Silicon Anomaly Sheet

AD1839

This document details known bugs in the current version of the AD1839.

Figure 4. Reset Synchronized to Rising Edge of FSTDM/ALRCLK

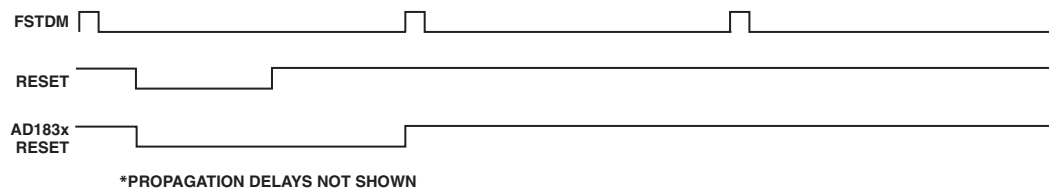
The ADC engine used in the AD1839 loads the serial port with the results of the last conversion periodically at the sample rate. The loading operation is initially determined by where the $\overline{PD/RST}$ pin goes high. For slave mode operation, the LRCLK or FSTDM signal have no fixed relationship so it is possible that the loading operation can occur in the middle of a data transfer. This results in the right ADC sample being one sample ahead of the left ADC sample, which presents itself as a phase shift. See Figure 1.

Synchronizing the rising edge of $\overline{PD/RST}$ with the appropriate LRCLK (for I²S, left or right justified modes) or FSTDM (for TDM256 mode) edge will ensure that the ADC result updates occur in a safe region and the phase shift will not occur. Figure 2 shows a synchronization circuit using a single flip-flop that latches the reset signal on the rising edge of FSTDM/ALRCLK. Figure 3 shows an alternate circuit for latching the reset on the falling edge of ALRCLK. Figure 4 shows a timing diagram associated with Figure 2. Table I lists the ADC modes affected by this issue and which circuit should be used to prevent it occurring.

ADC Mode	Safe Region	Recommended Circuit
I ² S	On rising edge of ALRCLK	Figure 2
Left Justified	On falling edge of ALRCLK	Figure 3
Right Justified	On rising edge of ALRCLK	Figure 2
TDM256	On rising edge of FSTDM	Figure 2
